REMARKS

Applicant submits this Preliminary Amendment in order to correct certain inconsistencies between the Specification and Figures.

AMENDMENTS TO THE DRAWINGS:

FIG. 5

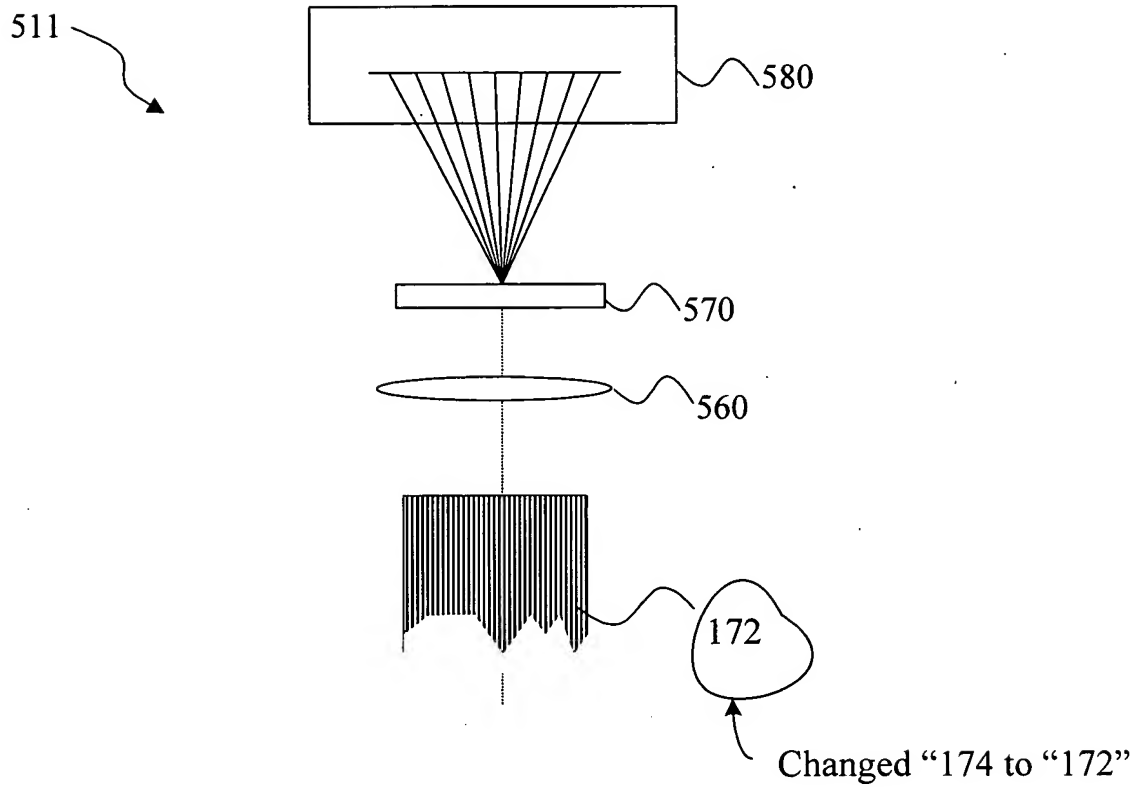
Fig.5 has been corrected by relabeling item 174 as item 172. Item 174 is defined as an “illumination bundle”, and item 172 is defined as a “sensor bundle”. Specification, p.13, ln.4. In the text corresponding to Fig.5, “light reflects off the wafer and is received by sensor bundle 172, which couples the light to lens assembly 560” Specification, p.21, ln.22-23. Thus, the amendment to Fig.5 makes the drawing consistent with the specification.

The attached drawing sheets include changes to Fig.5, Fig.7B, Fig.7C, Fig.13 and Fig.16. The change to Fig.5 consists of relabeling item 174 as 172. The change to Fig.7B and the change to Fig.7C each consists of relabeling item 620' as 620. The changes to Fig.13 consist of relocating label 180, adding label 1330, and relabeling item 1360 as 1355. The changes to Fig.16 consists of relabeling items 750, 760, 770 and 780 as items 1650, 560, 570, and 580, respectively.

FIGS. 7 (A) - (C)

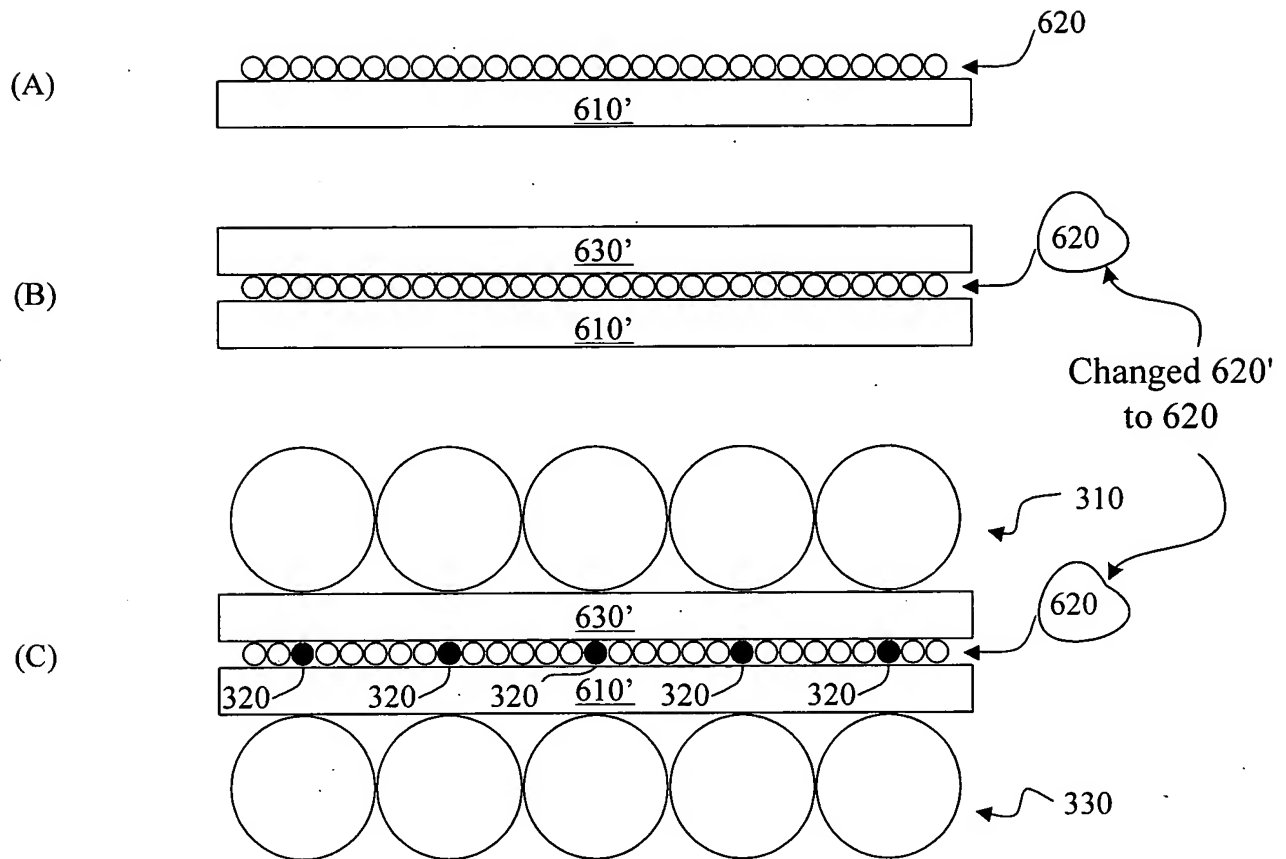
Fig.7B and Fig.7C have been corrected by relabeling item 620’ as item 620, in each figure. This makes the figures consistent with the Specification at p.23.

FIG. 13

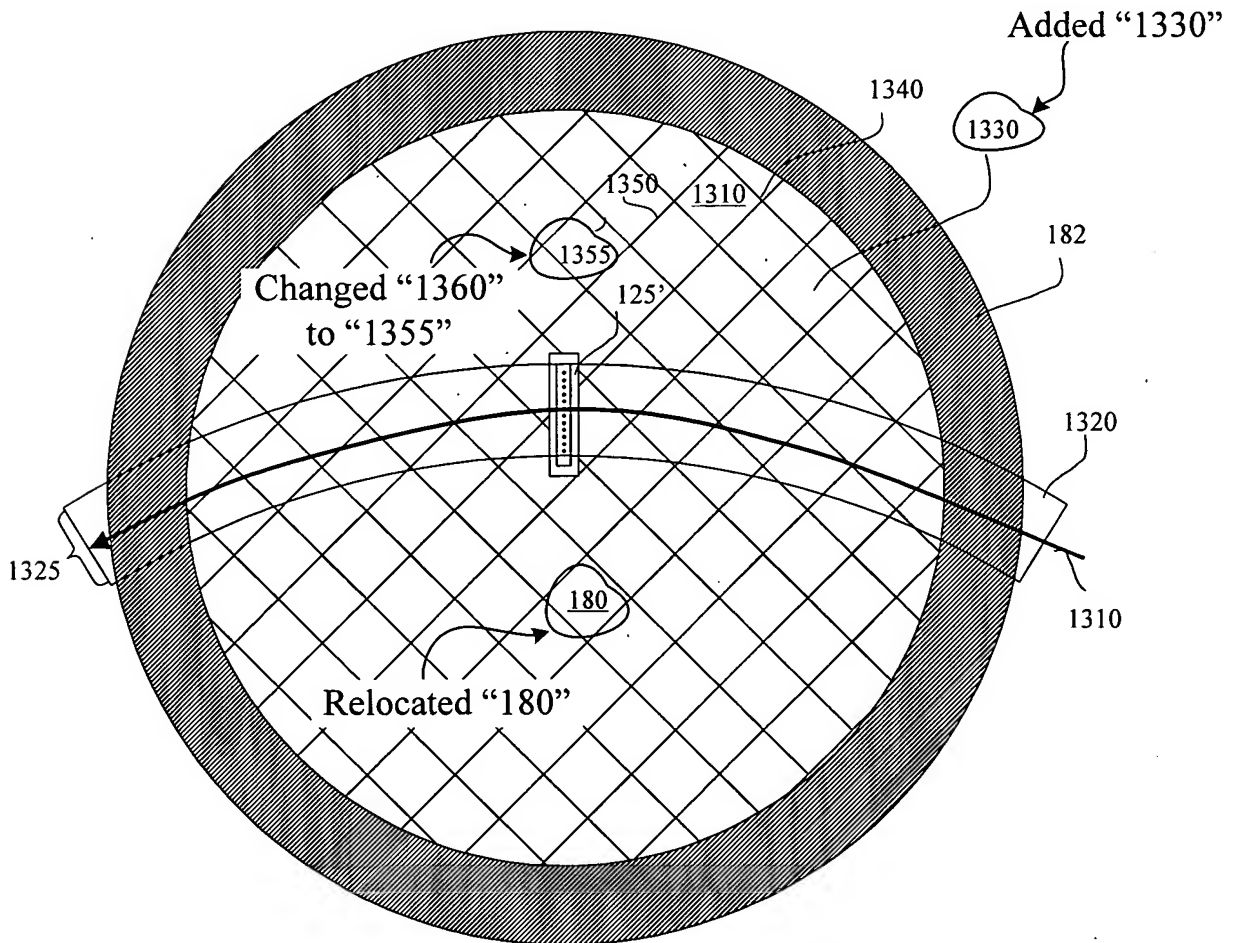
Fig.13 has been corrected by relocating label 180 closer to the center of the substrate and by underlining label 180 to suggest that label 180 indicates the entire substrate, rather than an individual die. Fig.13 has also been corrected by adding label 1330, which indicates a complete die, as described in the Specification at p.32, ln.27. Fig.13 has also been corrected by relabeling item 1360 (“transverse street”) as 1355, as described in the Specification on p.33, ln.3.

FIG. 16

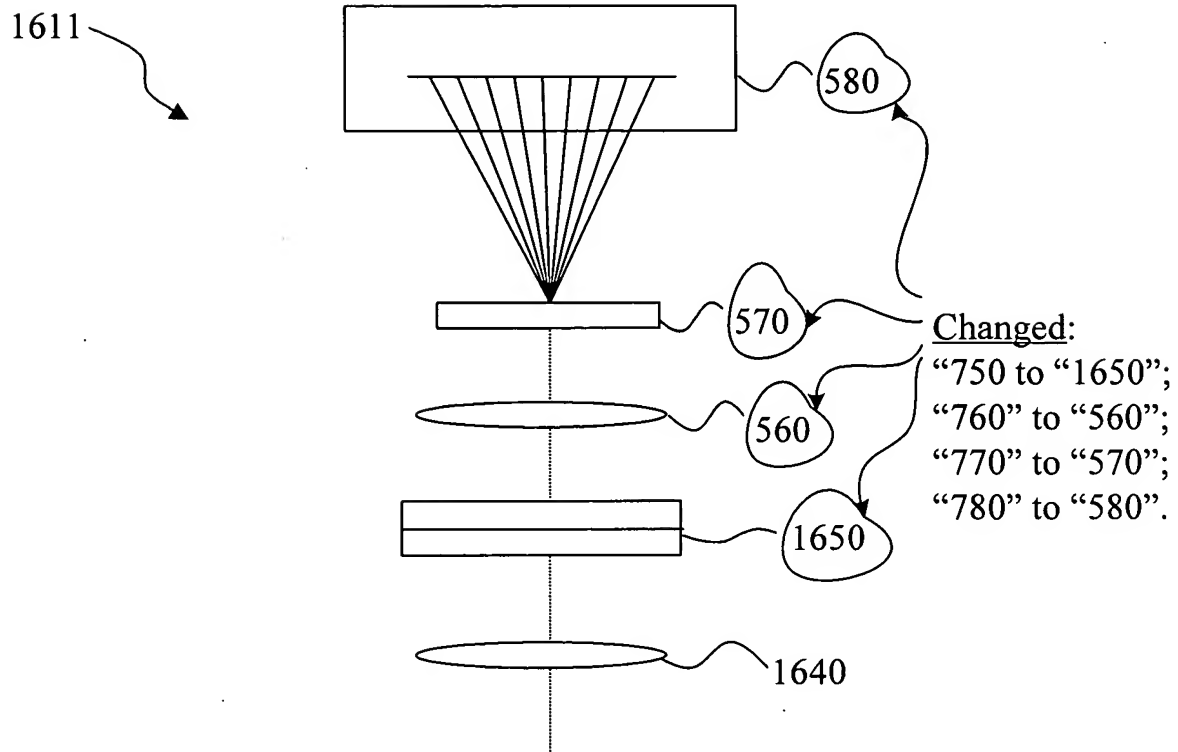
Fig.16 has been corrected by relabeling items 750, 760, 770 and 780 as items 1650, 560, 570, and 580, respectively. Identifying numerals 750, 760, 770 and 780 do not appear in the Specification. Thus, the “slit” which is clearly shown as item 750 in Fig.16 has been relabeled as item 1650. In addition, the “lens assembly”, “diffraction grating” and “imager” clearly shown as items 760, 770, and 780, respectively, on Fig.16, have been relabeled as items 560, 570, and 580, respectively. This labeling is consistent with labeling of similar components shown in Fig.5.

Finally, the Specification has been amended by rewriting the paragraph beginning on p.36 at ln.8 for consistency in view of the drawing amendments to Fig.16, to improve readability, and to correct grammatical errors. The paragraph has also been amended to describe items 1640 and 1650 originally shown but not described in Fig.16. Thus, no new matter is introduced by this or any of the above amendments.
